# Statement of Environmental Effects Section 4.55(1A) Modification

Jordan Springs Seniors Living Lot 1 in DP 1248137 Jordan Springs Boulevard, Jordan Springs

> DA/2018/0678 June 2019

Figure 6: Proposed colour scheme (Base Source: Lendlease Retirement Living)

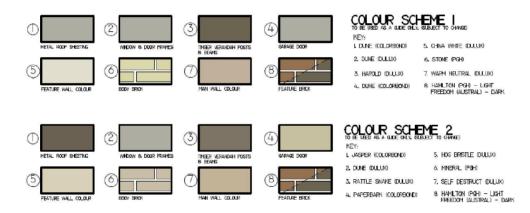
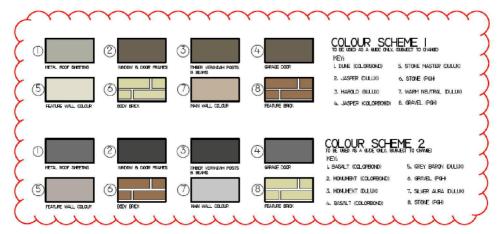
A colour scheme was prepared for the villas in the original DA and is included in Condition 1 of the development consent. The modification proposes to amend the colour scheme identified in the palette as shown in Figure 5. The amended colours are a slightly darker colour palette than what was approved as shown in Figure 6.

The proposed change is minor and maintains a similar colour palette as was approved. The proposed scheme incorporates a slightly darker palette and is considered to be suitable for the proposed development and site. The proposal maintains a similar architectural expression that was achieved through the approved colour scheme. Based on the above, the proposal is not likely to result in any adverse built form, streetscape or other impacts.

Figure 8: Proposed extract from Sheet 8 elevation demonstrating proposed maximum RL for Villa SV27 (Source: Lendlease Retirement Living)

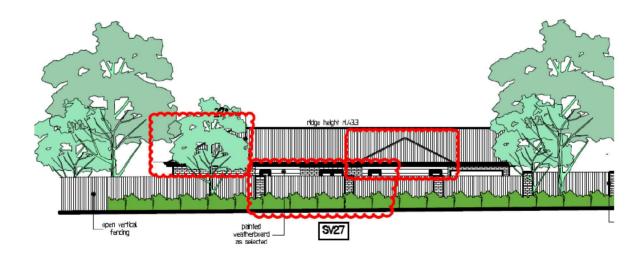
The approved civil plans included in Condition 1 (Site layout, cut and fill plan number 11048702/DA102 B) require fill to be placed across the majority of the site. The detailed engineering design has been completed to reflect the fill as part of the detailed design phase. As a result, the maximum RL's for Villas SV1 - SV7 and SV9 - SV27 inclusive, as detailed in Appendix 2, have increased marginally from between 0.03m to 0.59m. Figures 7 and 8 provides an extract of the approved and proposed elevation detailing the overall RL for comparison for Villa SV27.

Figure 10: Extract of proposed Villa SV45 detailing proposed hip roof design

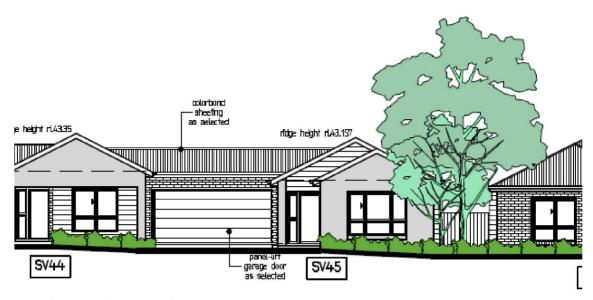
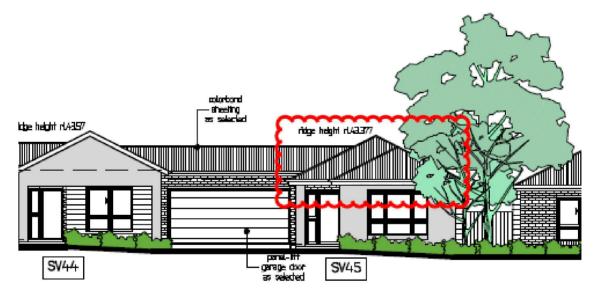
The modification seeks to reconfigure the roof design of approved villas SV2 – SV3, SV8 – SV9, SV11 – SV13, SV15, SV20, SV23, SV24, SV27, SV42 and SV45 from a gable design to a hip design as shown in the Figures 9 and 10 for Villa SV45. This is a minor design change which has resulted from further refinement undertaken by the project design team.
